Office Action Summary	Application No. 10/724,101	Applicant(s) OHMI ET AL.	
	Examiner Jennifer A. Leung	Art Unit 1764

DETAILED ACTION

FIG. 9

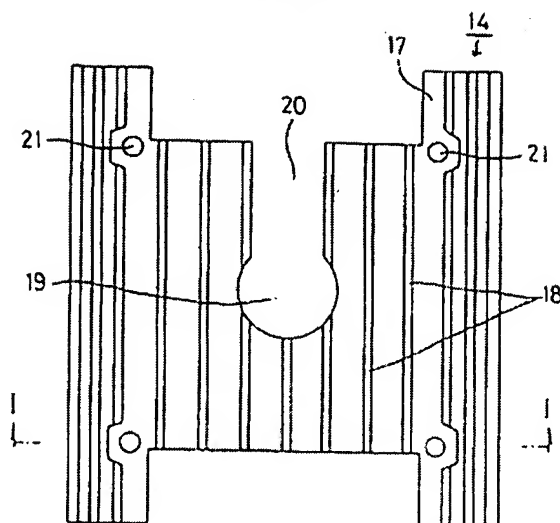
Regarding claim 7, it is unclear as to where the limitation of, "a notch... having a width of approximately the same diameter as the through hole," (lines 22-24), is disclosed in the specification and drawings. As seen in FIG. 9, the claimed notch is element **20** and the claimed through hole is element **19**. The notch and through hole of the fin base plate are also shown, but not labeled, in FIG. 11. As seen in the figures, the width of notch **20** is significantly smaller than the diameter of through hole **19**. Furthermore, the Examiner is unaware of any location within the specification where the dimensions of the notch **20** width relative to the through hole **19** diameter are disclosed.

The Examiner respectfully disagrees and maintains that the limitation of, “a notch connected with the through hole and having a width of approximately the same diameter as the through hole” is not supported in the originally filed disclosure. The relative dimensions of the notch 20 relative to the through hole 19 are not discussed in any portion of the specification. In addition, the Examiner maintains that one having ordinary skill in the art, when looking at Applicant’s FIG. 9, would not have considered the width of notch 20 to be of “approximately the same” as the diameter of the through hole 19, given the proportioning of the elements 19 and 20 as illustrated in the figure (copied below).

For example, if the width of the notch and diameter of the through hole were “approximately the same”, one having ordinary skill in the art would have expected the illustration to appear similar to plate 2 in FIG. 3(A) of Matsunaga et al., wherein a notch having a width that is approximately the same as the diameter of the through hole is shown as the cut out portion 2h. In contrast, Applicant’s illustration resembles that of FIGs. 6 and 8 of Matsunaga et al., wherein the width W of the notch is smaller than the diameter V of the through hole.
